Product Announcement

Improved Limit System for Hardwired Operators

Manaras-Opera's Improved Limit System

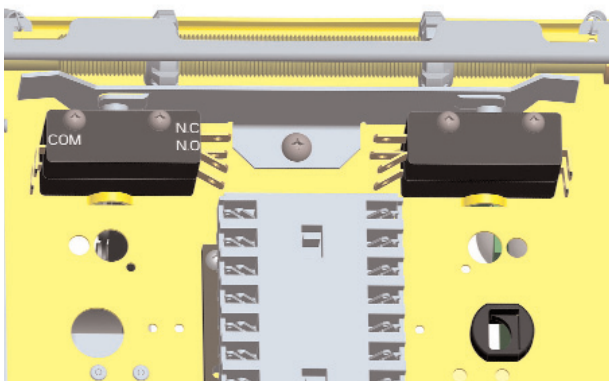
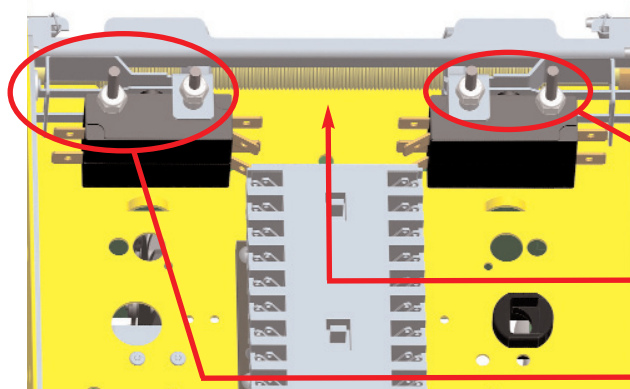
Screws are used as easy-access studs

Unique central lever has been eliminated

Independent lever on each limit

- Unique central lever has been eliminated.
- The Close and Open limits each have an independent lever which is specifically designed for a more consistent activation.
- The limit fastening screws have been used as studs in order to enhance accessibility.
